# Advisory

**Subject:** Recommended Modification  
CX4 & CX5 Tail Wheel Spring Mount

**Thatcher Aircraft, Inc.**  
1020 E. Jordan Street, Unit A  
Pensacola, Florida 32503  
850.712.4539  
thatchercx4@cox.net

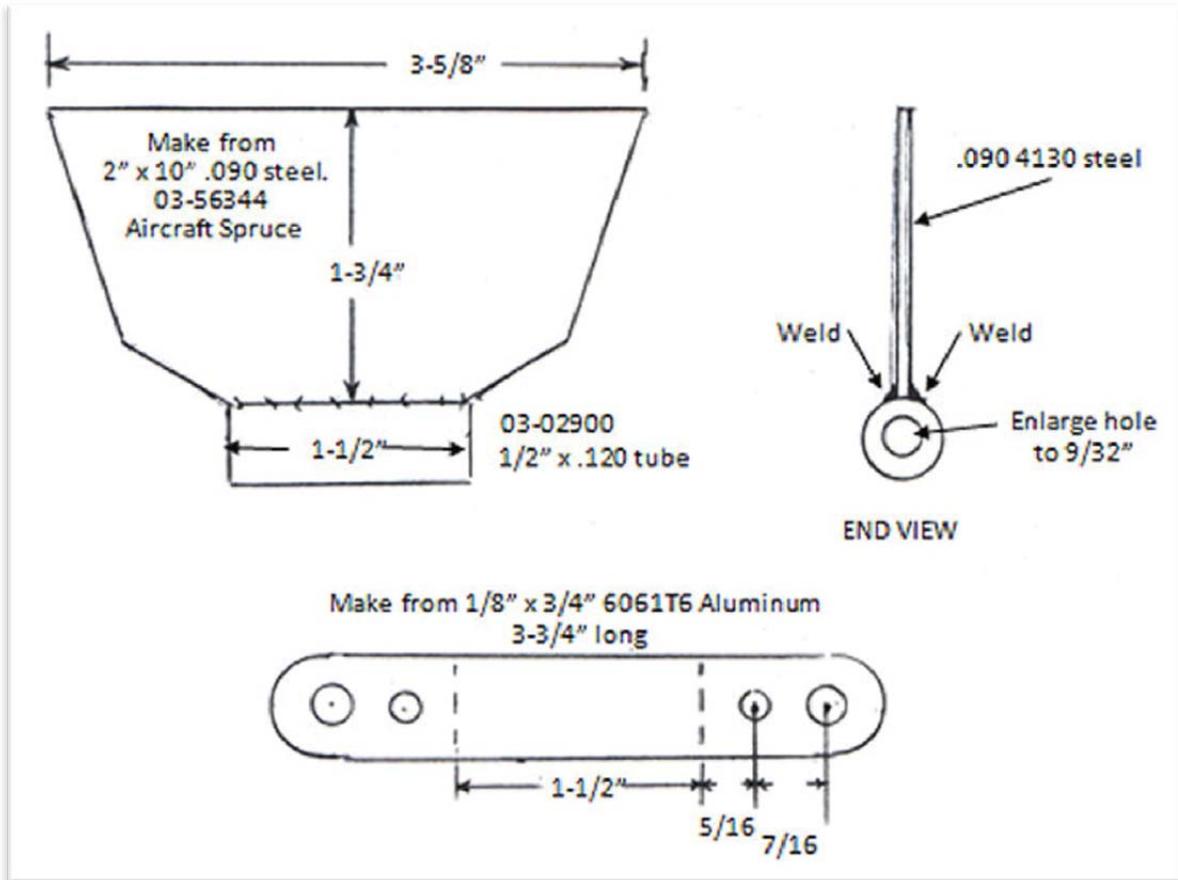
It was reported on February 26, 2015 that during a routine condition inspection of a CX4 with 485 hours of rough sod field operation, cracks were found on the F12 bulkhead where the tail wheel bracket attaches.

After investigation, cracks were found on the F12 bulkhead and lower skin due to a rocking action of the 3/16" x 1-1/2" mount angle for the tail wheel spring.

It is our recommendation to remove the angle and replace with the bracket shown in the drawings and photos in this advisory. This bracket allows the tail wheel spring to pivot without placing a load on the F12 bulkhead and lower skin.

A 1/4" rubber washer should also be placed between the spring and the skin at F11 to reduce stress on the attachment at F11 bulkhead.
